Permit Application Review

Permit No. Revised 2018-10

Applicant: Larry Smith; Lifespace Communities
Consultant: Ryan Bluhm; Westwood Professional Services
Project: Friendship Village
Location: S.E. Quadrant of T.H. 169 and I-494: Bloomington
Rule(s): 3,4,5,10,11,12
Reviewer: BCO

Permit #: Revised 2018-10
Project Name: Friendship Village Redevelopment: Bloomington
Approval Date: April 17, 2019

Exhibit #12

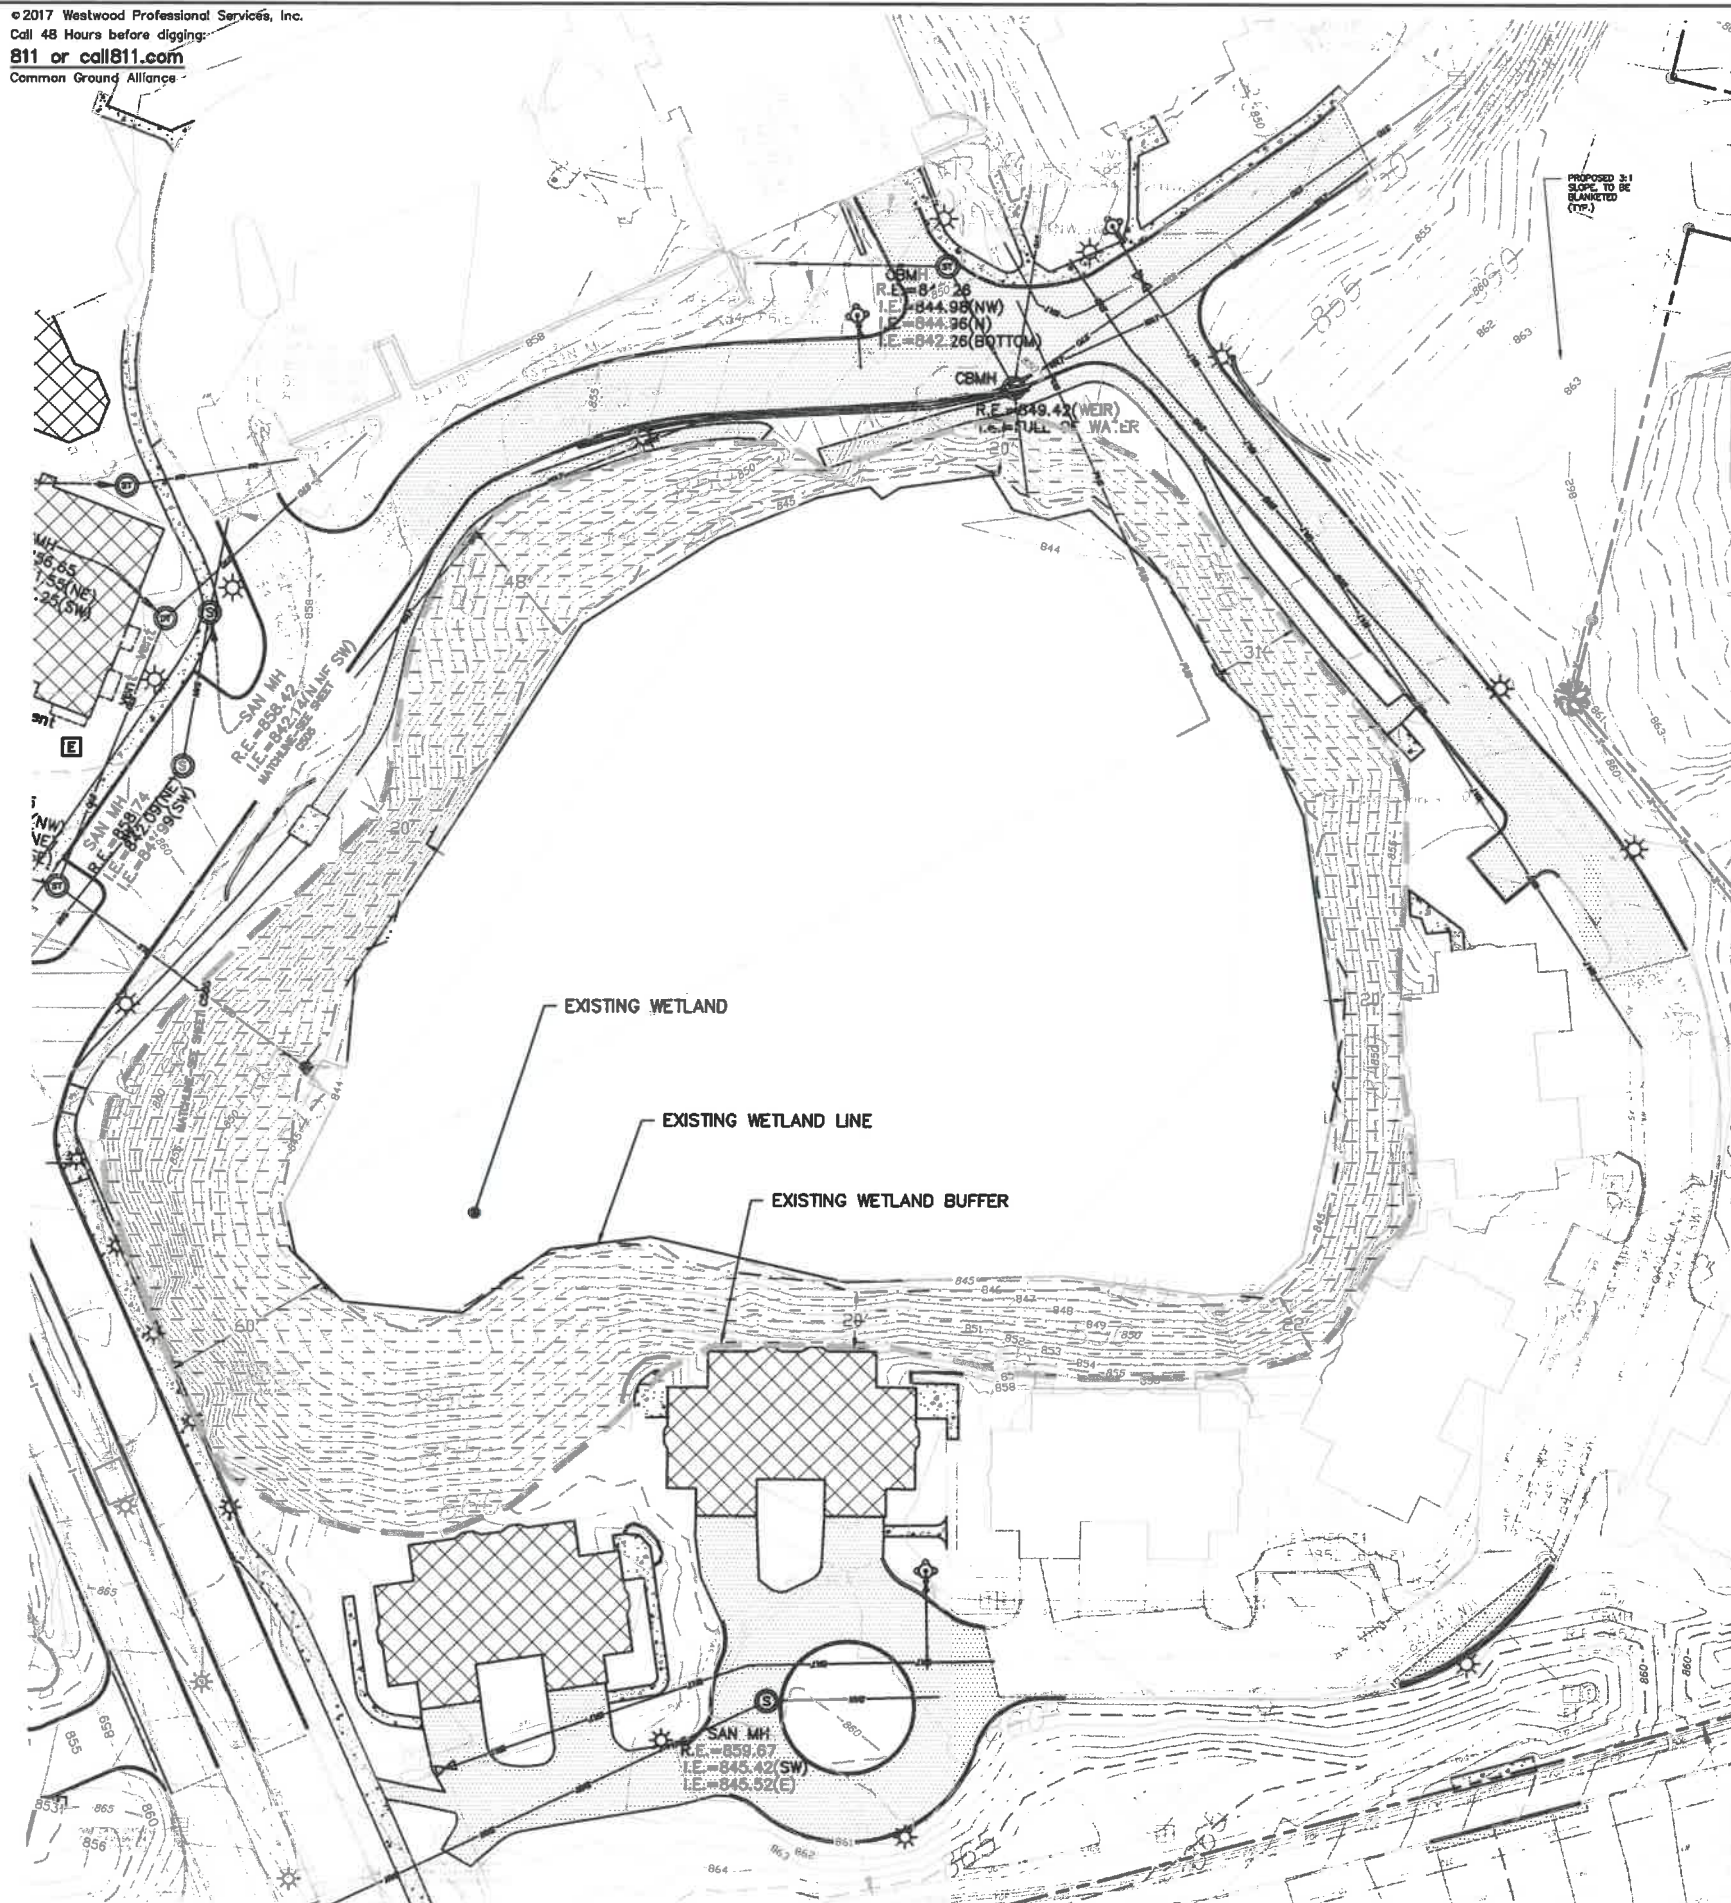
The current surface area of Wetland 1 is 82,621 square feet. When considering the proposed wetland impact, the final surface area of the wetland/pond will be 54,743 sf. Exhibit 12 provides details of the proposed wetland buffer areas. As a medium value wetland, the NMCWD requires a 20-foot minimum, 40-foot average buffer width adjacent to Wetland 1.

The proposed buffer seeding plan and landscape plan are depicted on Exhibit 12. The established buffers will be indicated by permanent, free-standing markers at the buffers upland edge. A marker will be placed along each lot line at intervals of no greater than 200 feet. Undisturbed buffer areas will be managed in a naturalized condition to encourage growth of native vegetation and eliminate invasive species and no structures shall be placed within the buffer. The buffer will be documented by a declaration approved by the District and recorded in the office of the county recorder.

1. Designated buffer areas will be seeded with Mesic Prairie General native seed mix (or comparable mix) as shown on **Exhibit 12**. Wetland seeding areas are also noted in Exhibit 12.

EXHIBIT 13

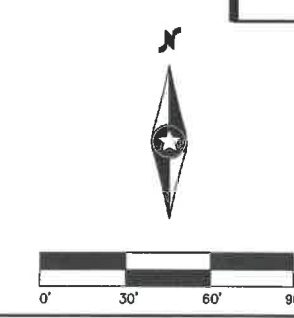
Total Existing Buffer = 44,342 SF (1.02 ac) (Estimated)
Current Length of Buffer Perimeter = 1,150'
Current Average Buffer Width = 38.6'
